# Maine Yankee

MN-96-145

Subject: Response to USNRC Request for Information (RAI) - Maine Yankee SBLOCA Analysis

**Non-Proprietary Responses<sup>1</sup>**  
**to**  
**USNRC RAI on SBLOCA Analyses**

Figure 9-3 Peak Cladding Temperature Versus Break Size

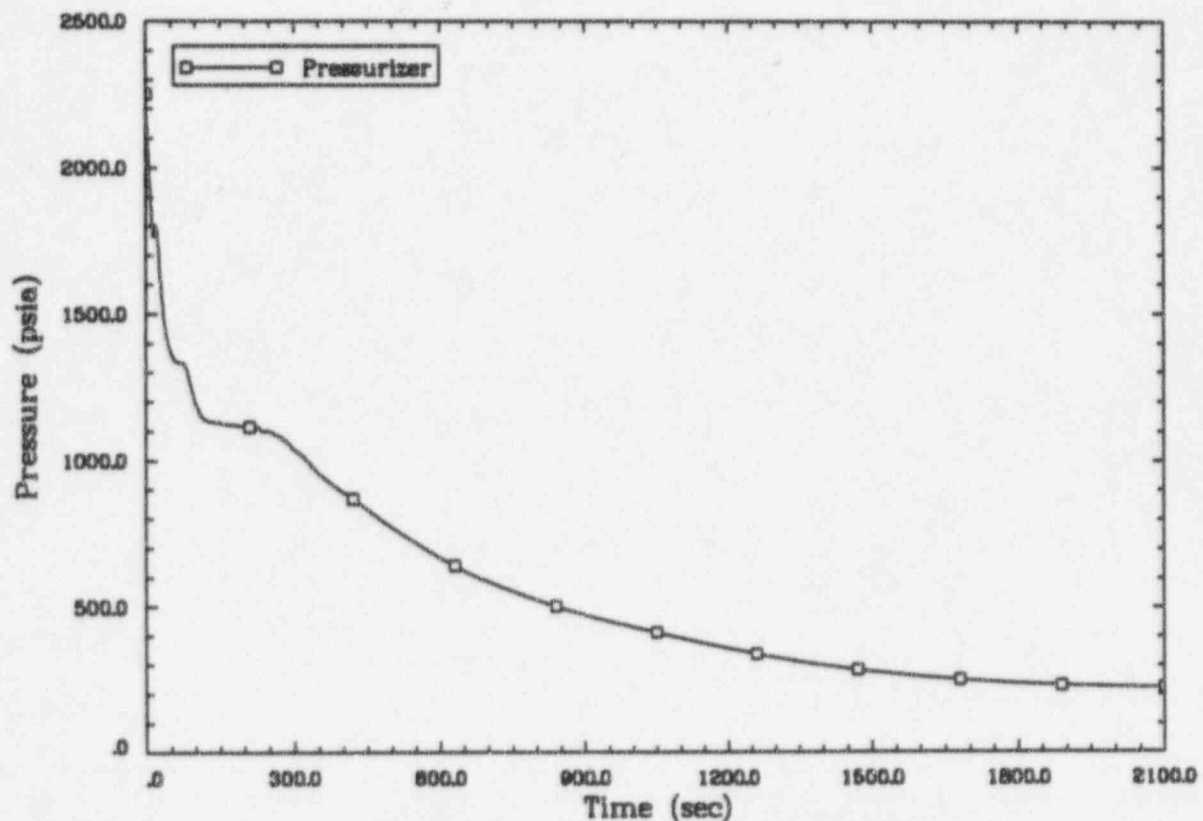
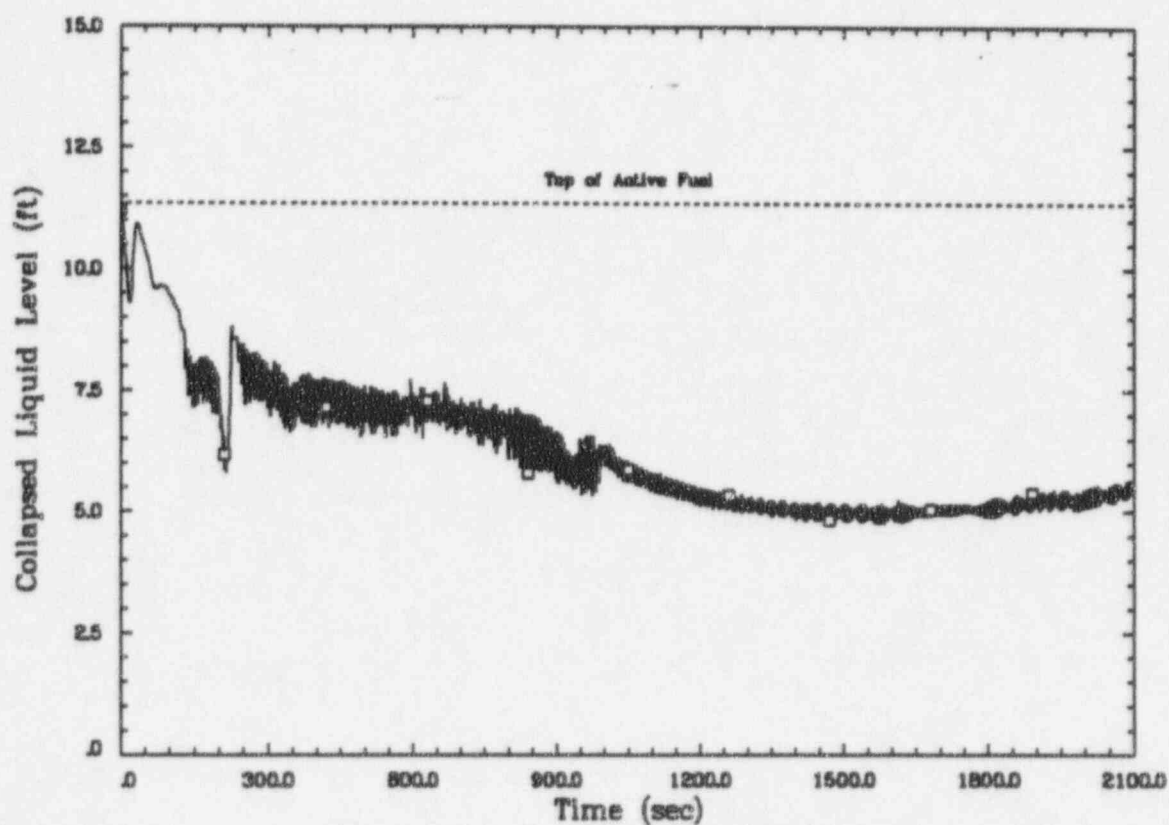
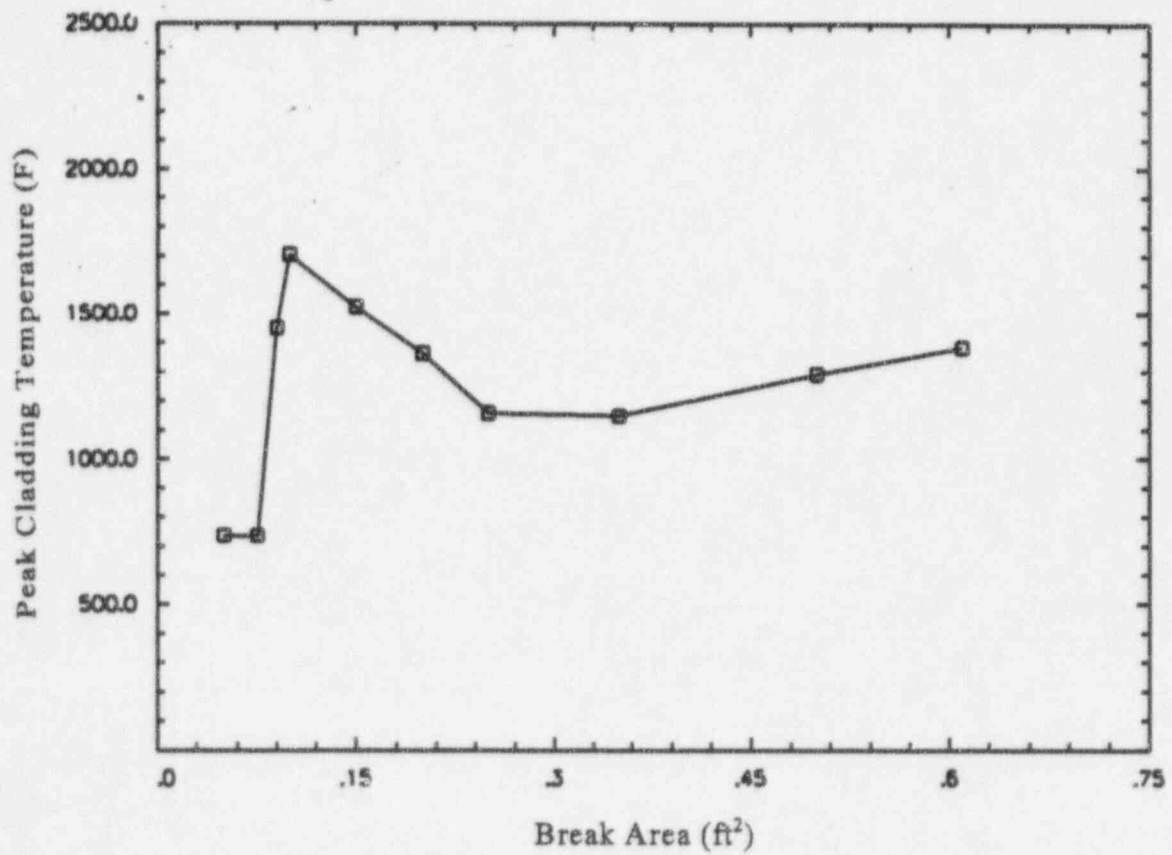
Tables 4.2 and 4.3 of your April 25, 1996, ANF-RELAP submittal show the results of the SBLOCA analysis for break sizes of 0.05, 0.10, 0.15, 0.20, 0.25 and 0.61 ft<sup>2</sup>. The staff notes that the analysis for the 0.05 ft<sup>2</sup> break predicted no heatup and thus showed a low PCT. The analysis for the next break size is the 0.10 ft<sup>2</sup> break, which results in the highest calculated PCT and is therefore identified as the limiting break size. Please analyze at least one more break size between 0.05 and 0.10 ft<sup>2</sup> that results in core heatup to verify that no break size in the stated range will be more limiting than the 0.1 ft<sup>2</sup> break.

Additional calculations were performed at break sizes of 0.35 ft<sup>2</sup> and 0.5 ft<sup>2</sup> to assure that there is no limiting break size between the previously analyzed break sizes of 0.25 ft<sup>2</sup> and 0.61 ft<sup>2</sup>. The PCTs calculated for break sizes of 0.35 ft<sup>2</sup> and 0.5 ft<sup>2</sup> were 1148°F and 1291°F, respectively. Figure 9-3 shows a plot of PCT versus break size for all of the break spectrum calculations. It can be seen that the trend of PCT versus break size for the 0.35 ft<sup>2</sup> and 0.5 ft<sup>2</sup> break sizes is as expected.

The 0.10 ft<sup>2</sup> break remains the limiting break size for the SBLOCA. \*

Figure 15-1 Integrated Break Flow  
for RCP Trip Delay Sensitivity

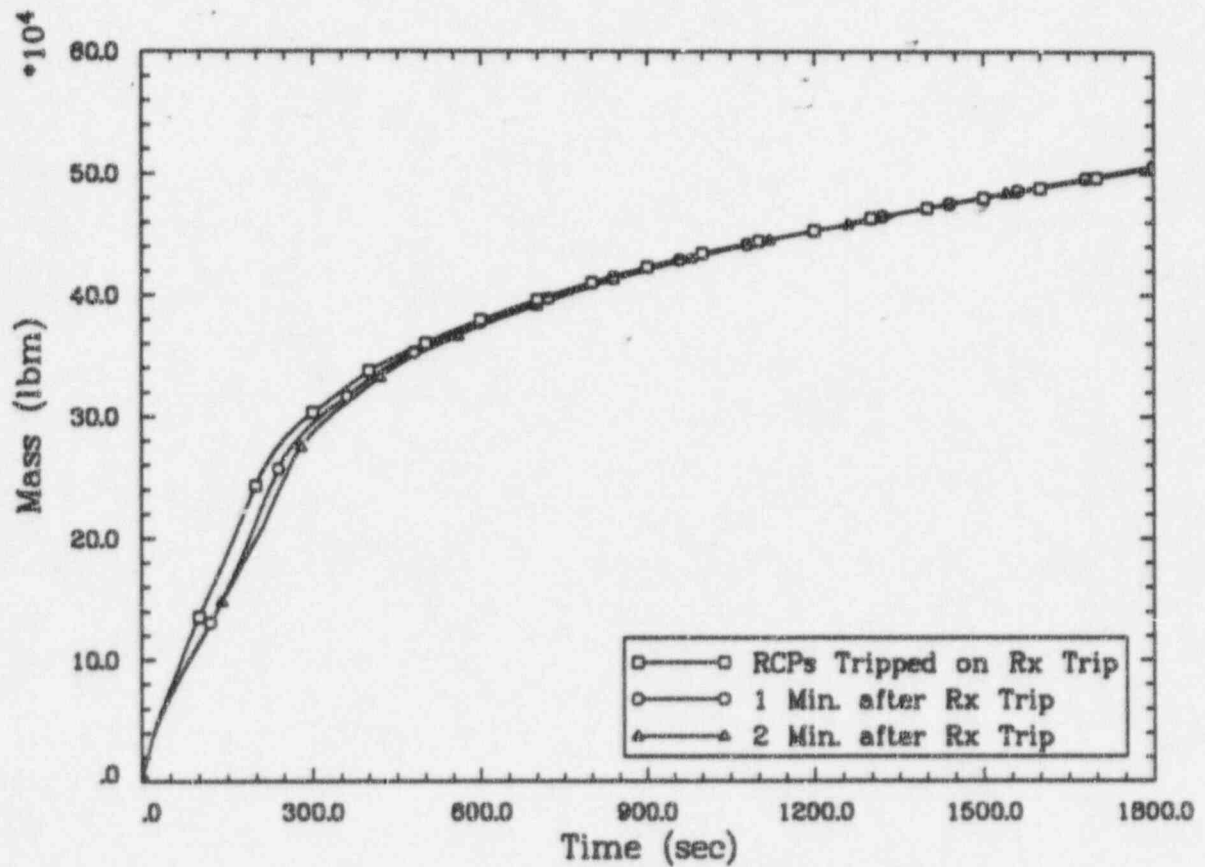
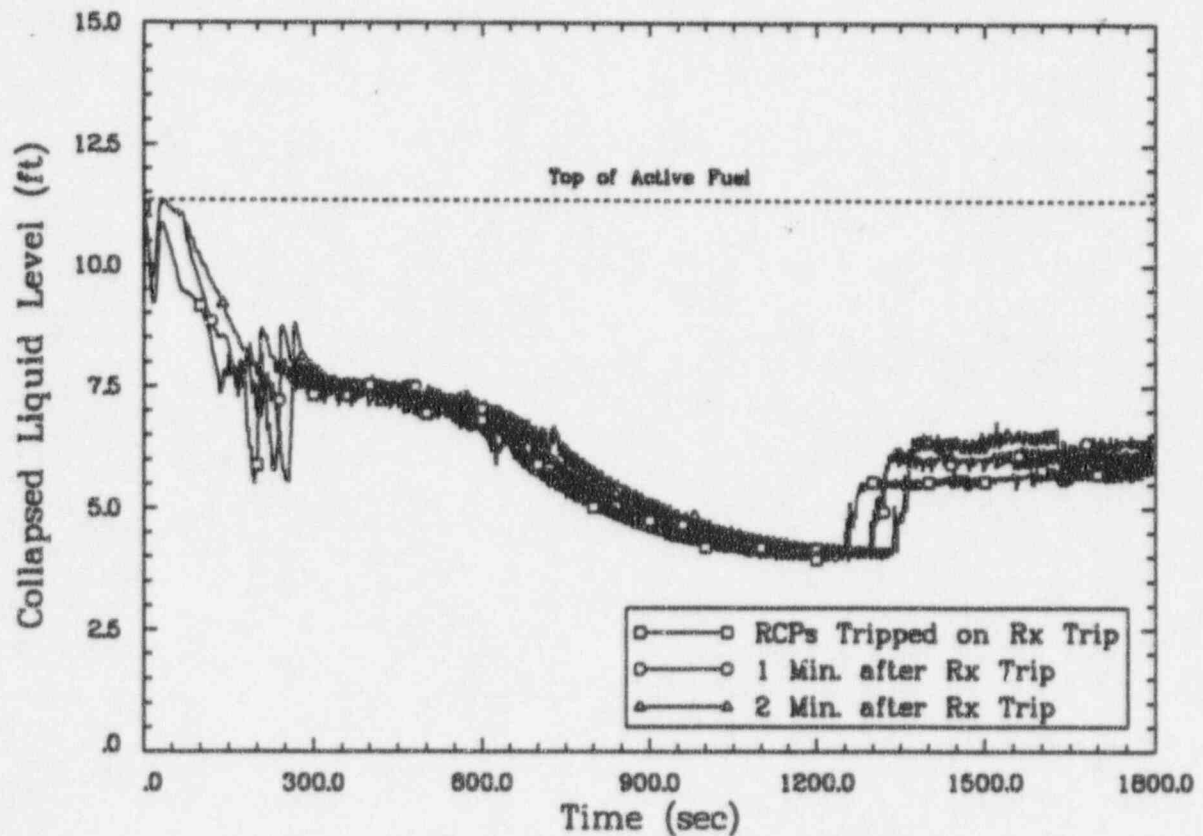
In Section 6.1 of its April 25, 1996, submittal, the licensee used the limiting SBLOCA case to address the adequacy of the two-minute reactor pump trip delay time to satisfy the requirements of TMI Item II.K.3.5. The staff considers the licensee's analysis to be qualitatively reasonable. To quantify the RCP trip delay time effect on the calculated PCTs, the licensee is requested to perform analyses for two cases: (1) the limiting SBLOCA with an RCP trip delay time of one minute, and (2) the limiting SBLOCA with an RCP trip delay of 2 minutes. In each case show compliance with the requirements of 10 CFR 50.46.

Two additional cases were analyzed to verify the above argument. The limiting case described in EMF-96-043 (0.10 ft<sup>2</sup> break, 73% axial power shape, minimum crossflow resistance) was reanalyzed with RCP trip delay times of 1 minute and 2 minutes. Figures 15-1 and 15-2 show comparisons of integrated break flow rate and core collapsed liquid level for the three cases, respectively. These figures verify that when the RCPs are tripped at scram, the break flow rate is higher prior to loop seal clearing and the eventual core collapsed liquid level is lower. The PCTs for the 1 minute and 2 minute RCP trip delay time cases are 1740°F and 1671°F, respectively, as compared to a PCT of 1781°F for the case with RCPs tripped at scram.

Thus, RCPs tripped at scram bound RCP trip delay times of up to 2 minutes as stated in EMF-96-043. The requirements of 10 CFR 50.46 are satisfied for the three cases analyzed.
